NEW CARGO-STEAMER No 141

STEM, STERNPOST AND RUDDER.

Sternframe, radeler and stem

Ams Rpt no. 8067.

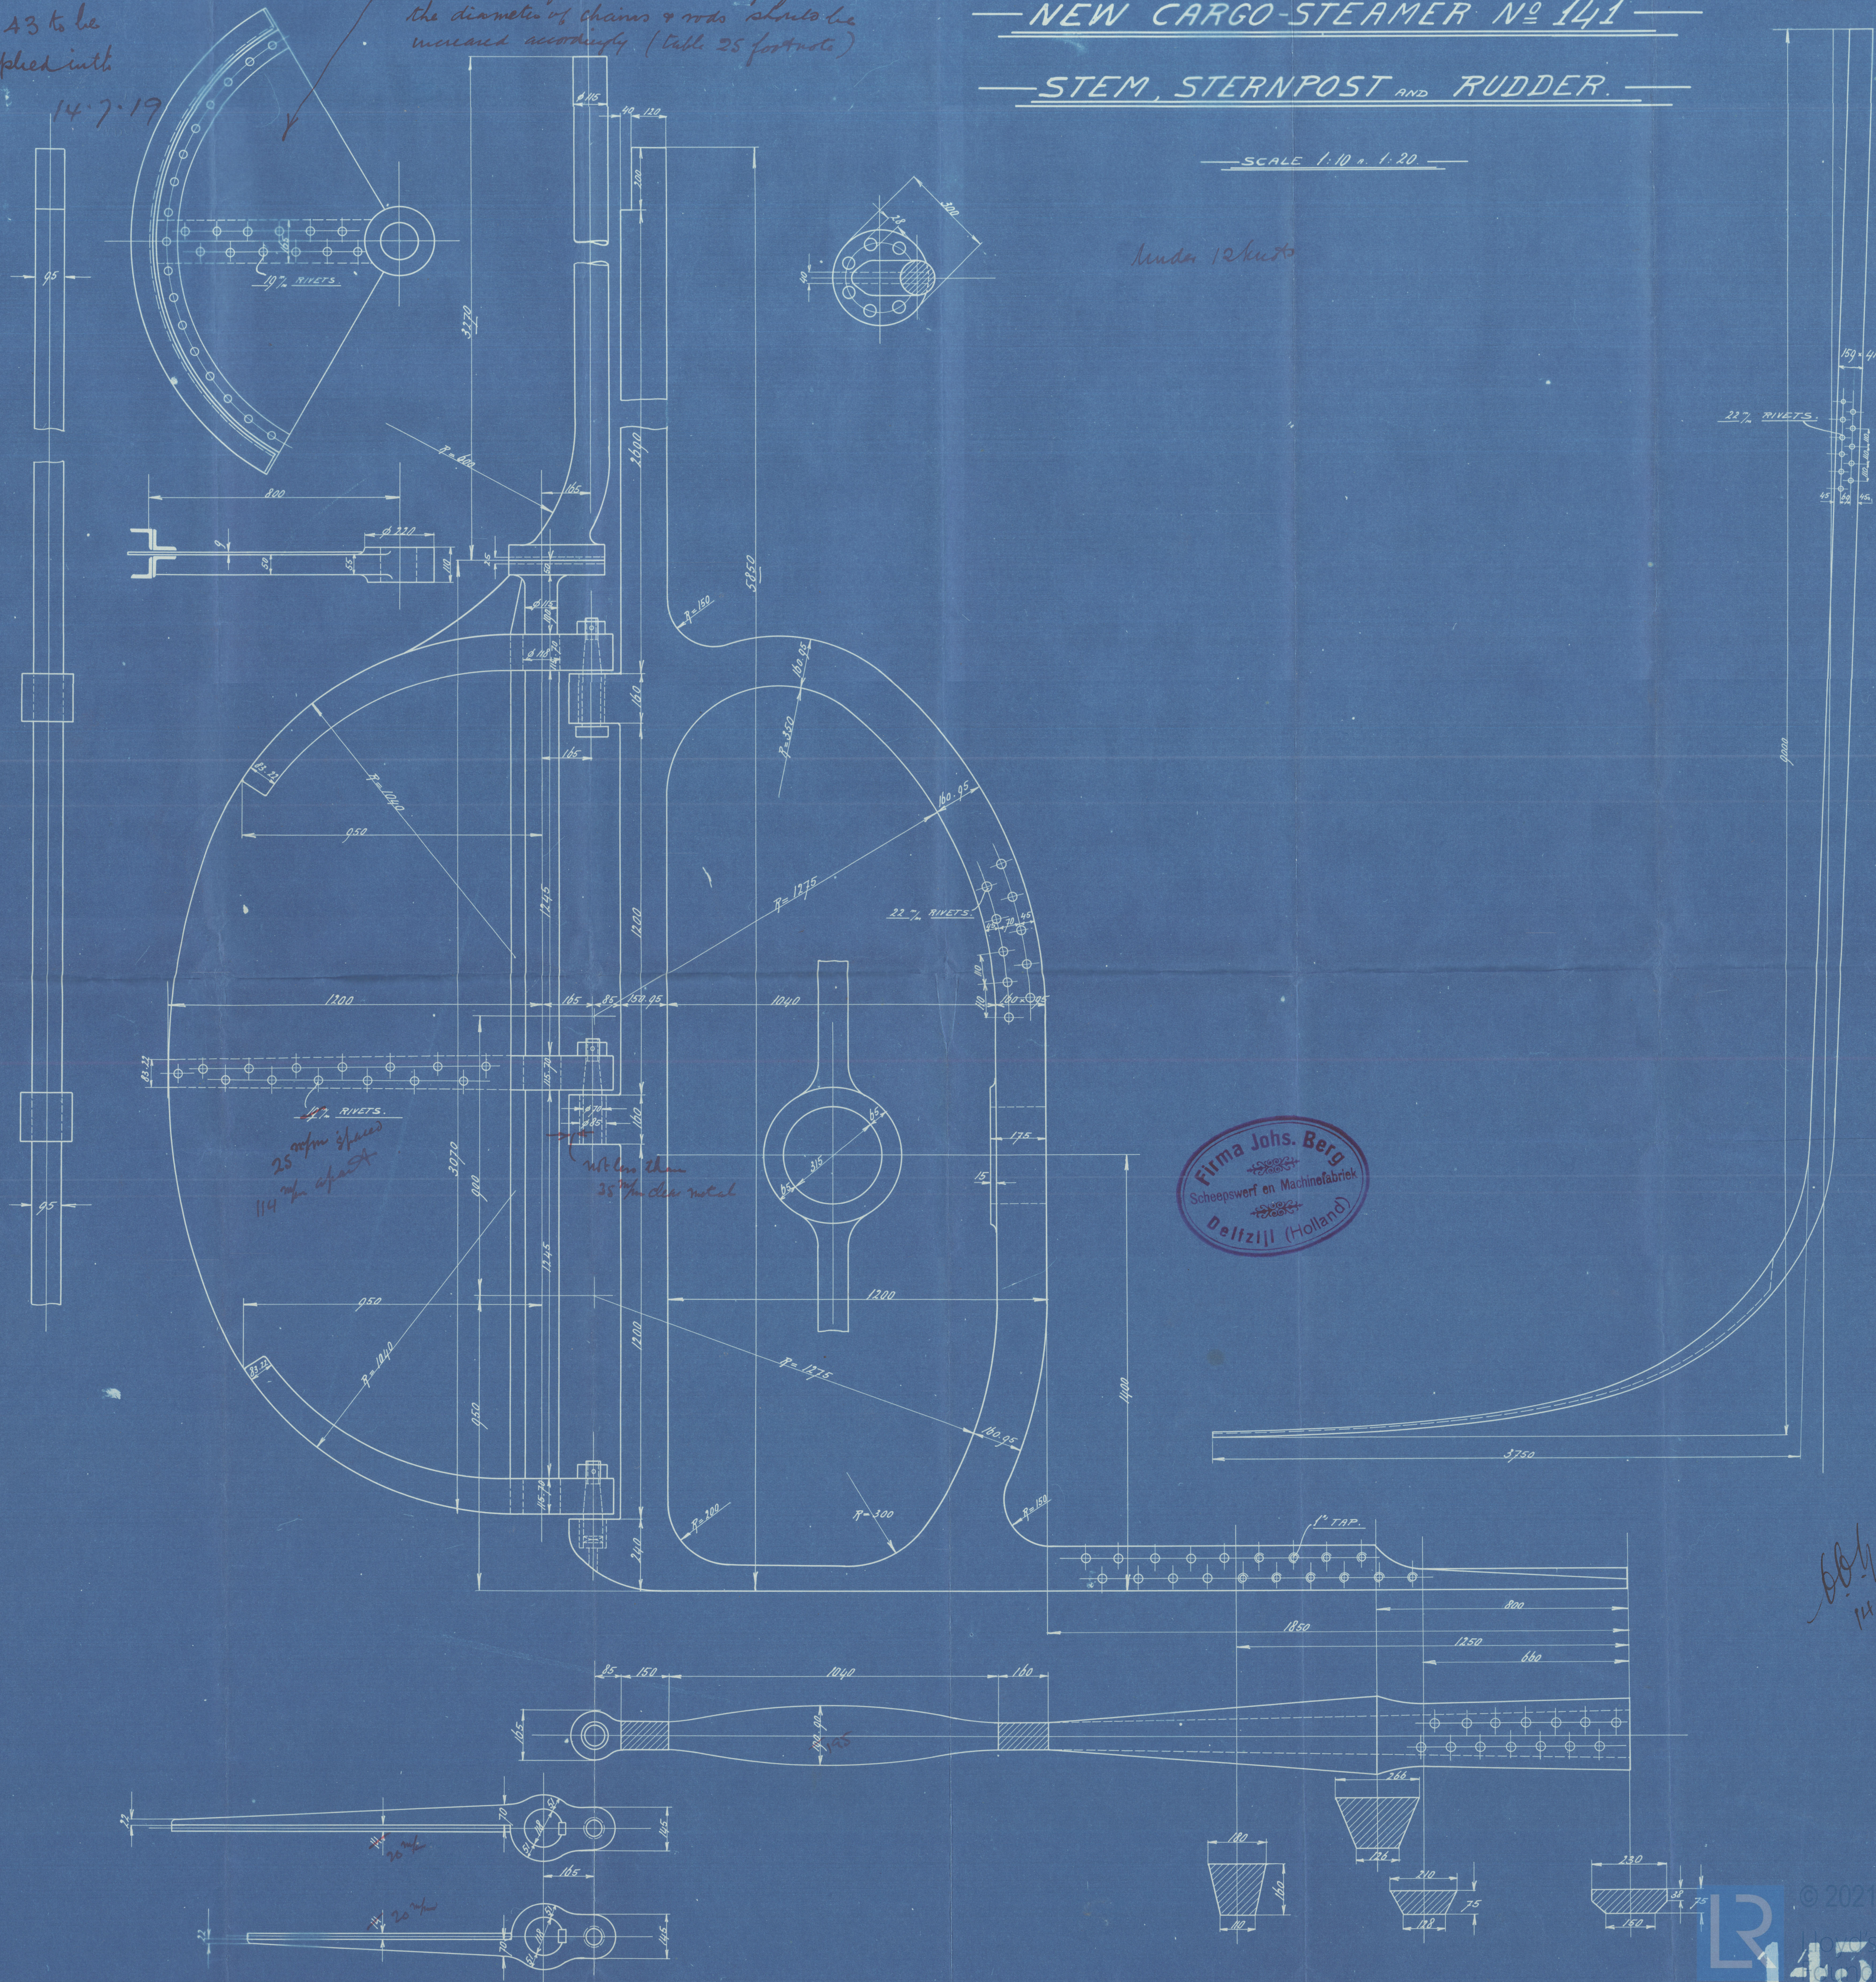
On account of reduced radius of quadrant
the diameter of chains & rods should be
increased accordingly (Table 25 footnote)
